STAFF REPORT
(One-Step Final Plat)

CASE NUMBER: SUB 2001-104 -- HAN DIEC ADDITION

LOCATION: North of Kellogg, West side of Greenwich Road

VICINITY MAP

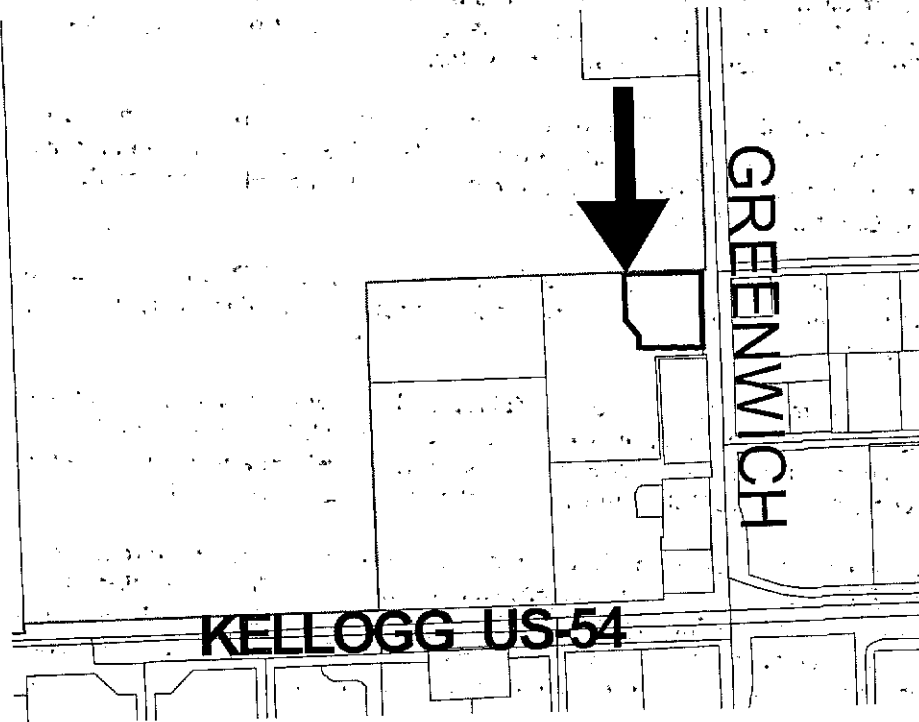
*Easement for SS
to plat to the south?*
